STAFF RECOMMENDATION
1821 5th Avenue North
June 19, 2019

Application: New Construction—Outbuilding/Detached Accessory Dwelling Unit;
District: Salemtown Neighborhood Conservation Zoning Overlay
Council District: 19
Map and Parcel Number: 08108026200
Base Zoning: R6A
Applicant: Cheyenne Smith
Project Lead: Melissa Baldock, melissa.baldock@nashville.gov

Description of Project: Application is to construct an addition to the historic house. The addition will more than double the footprint of the historic house.

01 FIRST LEVEL FLOOR PLAN

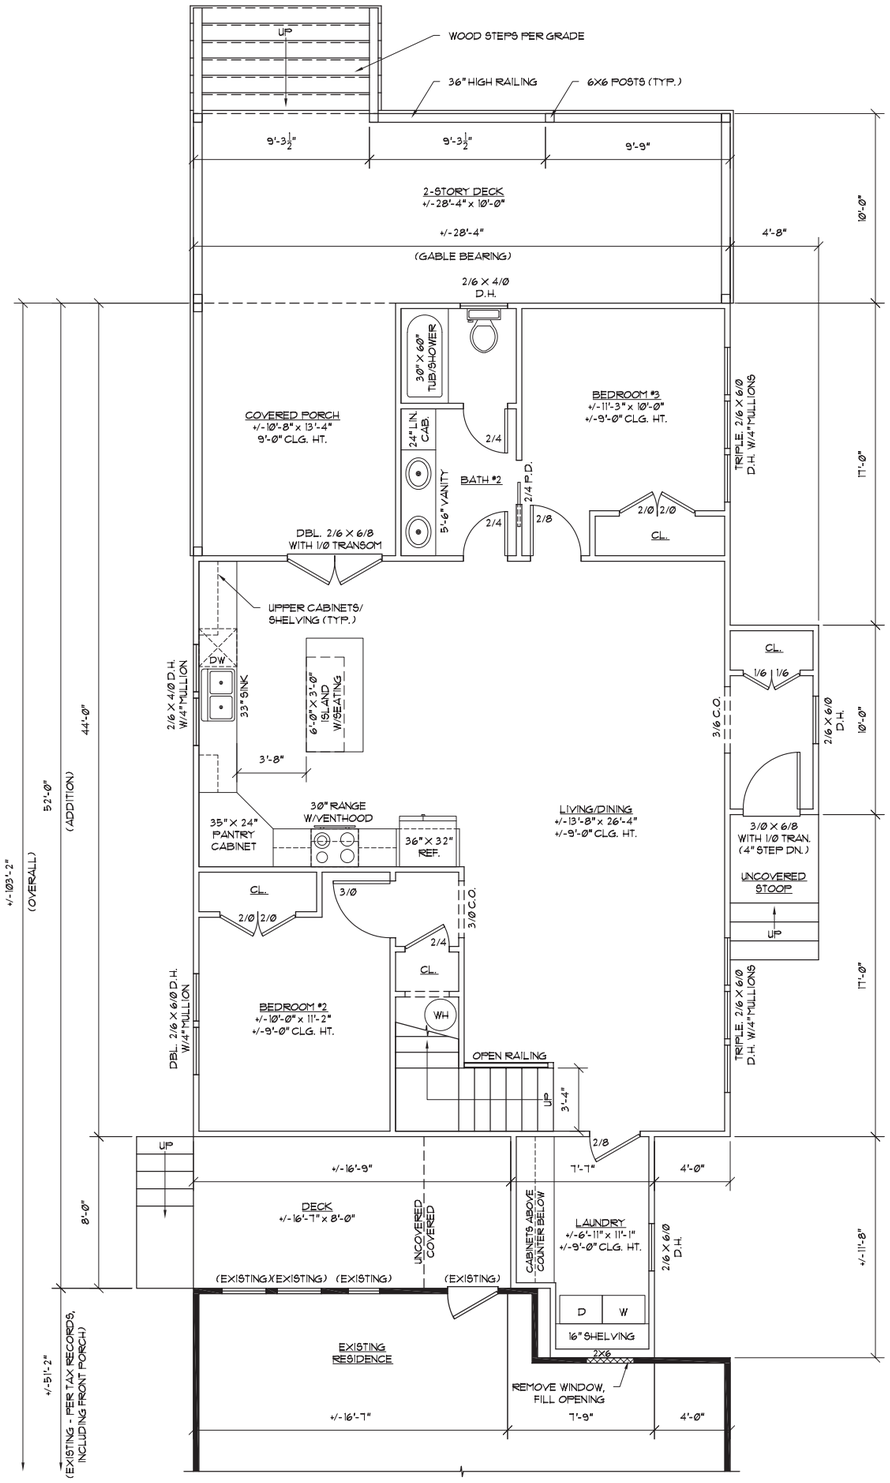
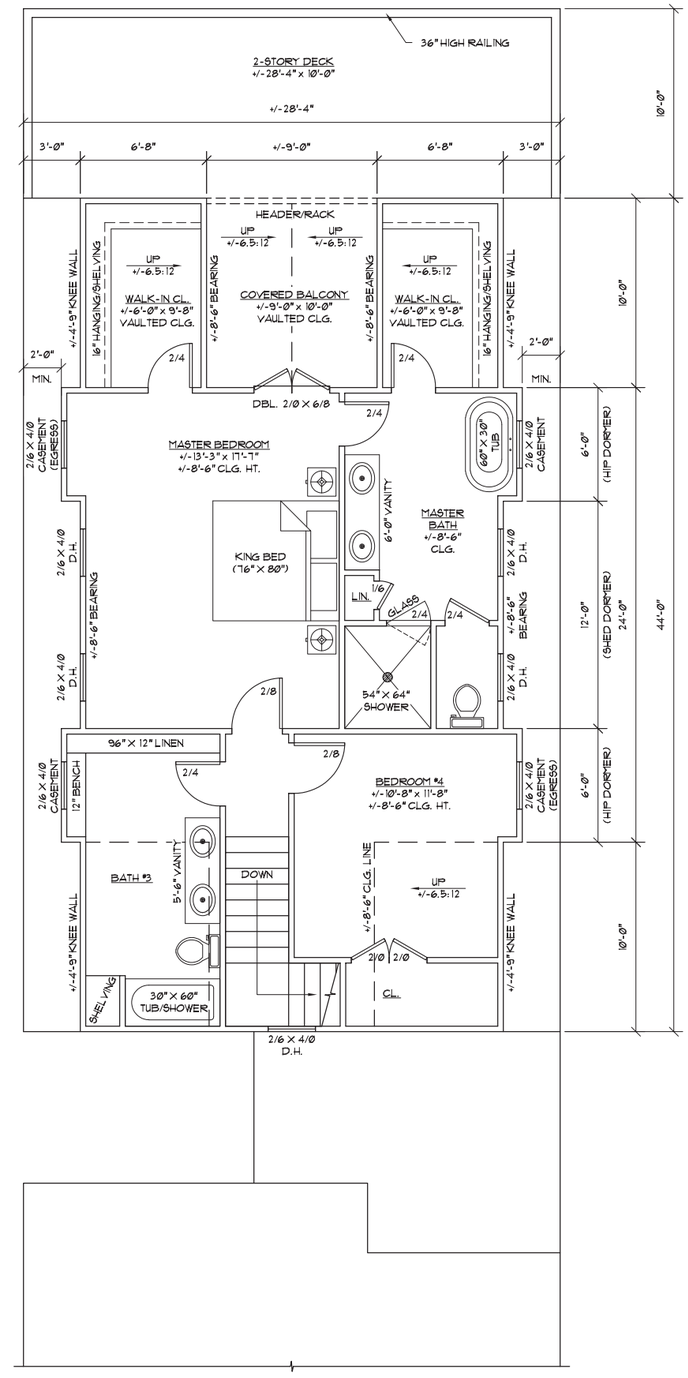
The historic house has a depth of approximately fifty-one feet (51'), including the front porch. The proposed addition is deeper than that of the historic house, with a depth of sixty-six feet (66'). The footprint of the addition is also larger than that of the historic house. The existing house has a footprint of approximately one thousand, four hundred, and twelve square feet (1,412 sq. ft.). This includes the front porch. The addition, including the two-story deck at the rear has a footprint of approximately one thousand, six hundred, and ninety square feet (1,690 sq. ft.). The footprint of the addition more than doubles the footprint of the historic house, which is not something that has been approved recently, except in cases of exceptionally small historic houses.

Staff finds that the larger footprint is not appropriate in this case since the house's footprint is not unusually small. In addition, the addition is already taller and wider than the historic house and having a footprint that is larger than the footprint of the historic house makes the overall height and scale of the addition inappropriate. Staff recommends that the addition, including all covered porches and uncovered decks, have a footprint no larger than one thousand, four hundred, and twelve square feet (1,412 sq. ft.), which is the footprint of the historic house.

1. The footprint of the addition, including all covered porches, covered decks, and two-story decks, be no larger than one thousand, four hundred, and twelve square feet (1,412 sq. ft.), which is the footprint of the historic house;
2. A walkway be added from the sidewalk to the new, secondary entry to the rear unit;
3. Staff approve the final details, dimensions and materials of windows and doors prior to purchase and installation;
4. Staff approve the roof shingle color and texture prior to purchase and installation;
5. The HVAC be located behind the house or on either side, beyond the mid-point of the house; and
6. Utility meters be located on the sides or rear of the building. Alternative mechanical and utility locations must be approved prior to an administrative sign-off on the building permit(s).

01 FRONT ELEVATION (NORTHEAST)

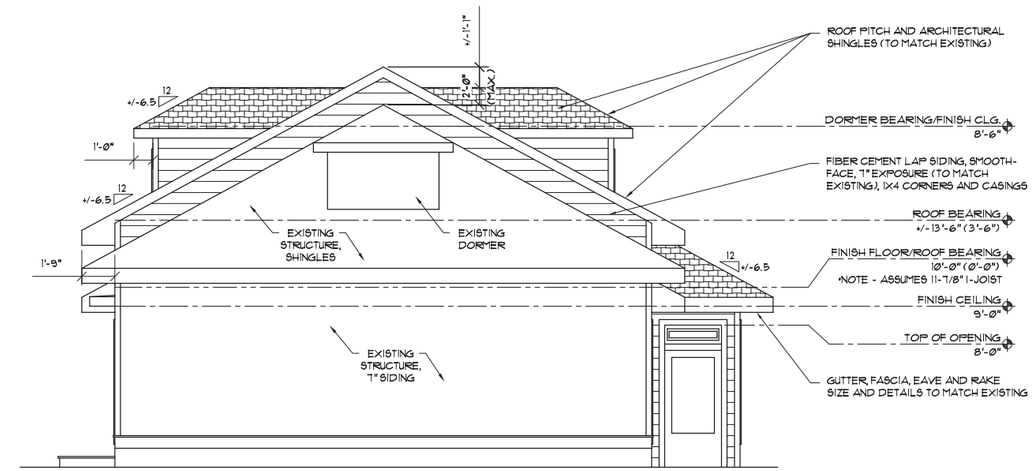
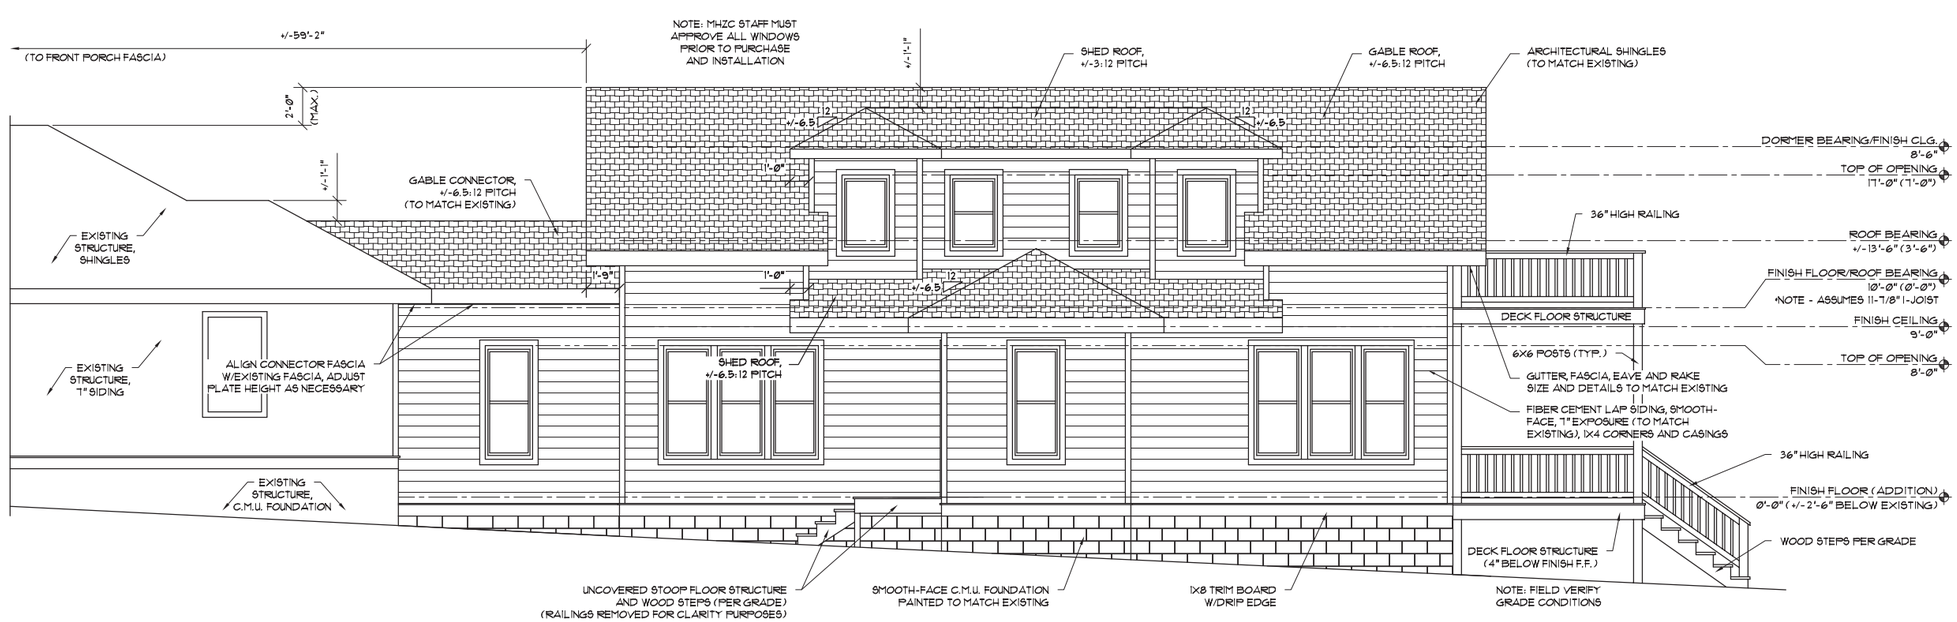
Height & Scale: The proposed addition will be one-and-a-half stories and two feet (2') taller in ridge and eave height than the historic house. The design guidelines allow for two-foot (2') ridge raises for side gables houses. A hipped roof like the one at 1821 5th Avenue North is not eligible for a ridge raise, but staff does find that an addition that is two feet (2') taller than the historic house could be appropriate if the rest of the addition's scale is subordinate to the historic house. The addition is designed so that no part of the addition is any taller than two feet (2') taller than the outline of the roof.

On the right side, there is a small portion of the addition that is wider than the historic house. A wider addition may be appropriate for this house and lot because the house is less than thirty feet (30') in width at twenty-eight feet (28') wide, and it is shifted on the lot. The wider portion of the addition will just be one-story in height and will only extend to be four feet, eight inches (4'8") wider than the historic house.

Orientation: The addition will add a second residential unit to the lot. The entry to the rear unit will be incorporated into the wider portion of the addition. Staff finds that this second entry stoop is designed so that it reads as a side or secondary entry and that it does not affect the historic house's orientation towards 5th Avenue North. Staff recommends that a walkway be added from the sidewalk to the secondary entry. Vehicular access to the site will be via the rear alley.

With the condition that a walkway be added from the sidewalk to the secondary entry, staff finds that the addition meets Sections III.F. and IV. of the design guidelines.
